AERONAUTICAL CHARTING FORUM Instrument Procedures Group October 23, 2012

FAA Control # 12-02-302

Subject: Multiple Climb Gradients on Standard Instrument Departure (SID) Charts.

JEPPESEN SALT LAKE CITY

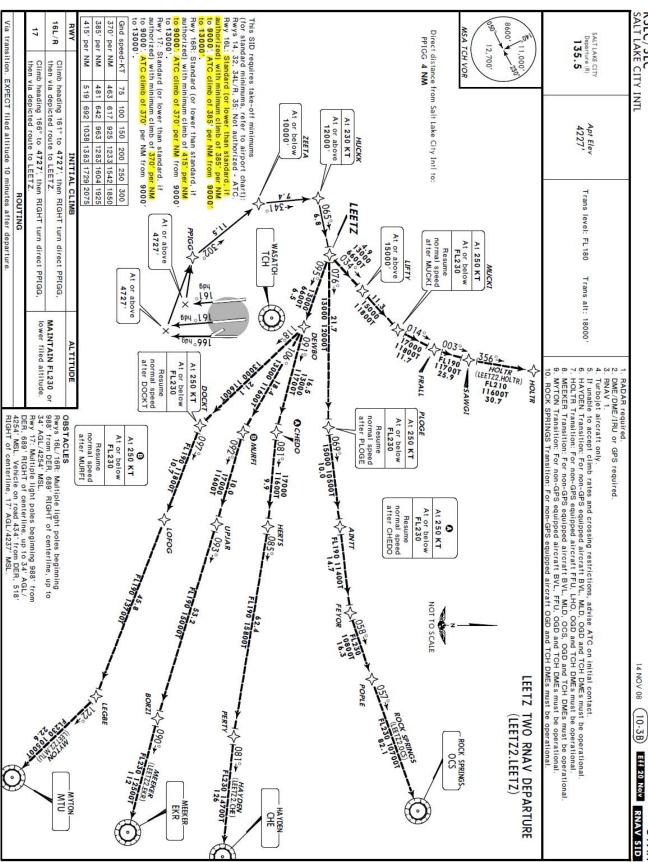
Background/Discussion: Multiple climb gradients are currently being depicted on some SID charts; one for obstacle clearance and one for ATC altitude restrictions. This practice has recently started at Salt lake City (SLC) - see the attached LEETZ 2 RNAV Departure. Previously, only the min climb gradient was annotated on this chart and having multiple CG's clutters up the chart unnecessarily. FAA order 8260.3, *US Standard for terminal Instrument Procedures (TERPS)*, allows only one climb gradient for obstacle clearance purposes. However, FAA Order 8260.46, *Departure Procedure (DP) Program*, allows multiple climb gradients when necessary for ATC purposes.

Multiple climb gradients, especially when duplicated, contribute to unnecessary chart clutter.

Recommendations: Revise policy to specify that only the highest required climb gradient for any given segment of a SID be specified on the procedure.

Runway 14, 16L, 32, 34L/R, 35: *Minimum climb rate 385' per NM to 13,000.*Runway 16R: *Minimum climb rate 415' per NM to 9000', 370' per NM to 13,000'*

Runway 17: Minimum climb rate 370' per NM to 13,000'

Initial Discussion - MEETING 12-02: New recommendation presented by Kevin Allen, US Airways. Kevin expressed concern that there are SIDs that have multiple climb gradients published; one for obstacle clearance and one (or more) for ATC altitude restrictions. This appears to be a contradiction between two FAA 8260-series Orders. Order 8260.3, US Standard for Terminal Instrument Procedures (TERPS) allows only one climb gradient for obstacle clearance purposes. However, FAA Order 8260.46, Departure Procedure (DP) Program, allows multiple climb gradients when necessary for ATC purposes. These multiple climb gradients, especially when duplicated, contribute to unnecessary chart clutter. US Airways recommends the FAA revise policy to specify that only the highest required climb gradient for any given segment of a SID be specified for the departure procedure. Kevin also recommended that charting could use a slash (/) vice "per" when specifying the climb gradient; e.g., "360'/NM" vice "360' per NM". Bill Hammett, AFS-420 (ISI) responded that there are restrictions on the use of symbols allowed in international NOTAMs; however, he was unsure if the slash is restricted. Tom Loney, Canadian Air Force, mentioned that not all aircraft have the same climb performance capabilities; therefore, pilots of less capable aircraft should have all the relevant information available. Tom Schneider, AFS-420, stated that criteria drives policy. The new Order 8260.58, which was effective September 12, 2012 and replaced Orders 8260.44, 8260.45, 8260.52, and 8260.54, as the standard for RNAV procedures. removed the provision that allowed multiple climb gradients. As noted above, Order 8260.3 also allows only one climb gradient; therefore, all reference to multiple climb gradients has been removed in the upcoming guidance in Change 3 to Order 8260.46. The premise is "one altitude at a fix will define one climb gradient". The scenario used in the example given by US Airways will be eliminated in the future. Chris Jones, AFS-410 (Support), stated that this scenario could cause an adverse impact in that some operators who cannot meet the specified climb gradient may not be able to use the procedure. Tom Schneider, AFS-420, responded that this has been discussed at several FAA/industry ad hoc departure meetings/telcons and the consensus was that this is acceptable. The group consensus is that the issue may be closed based on Order 8260.58 and the upcoming Change 3 to Order 8260.46. ITEM CLOSED
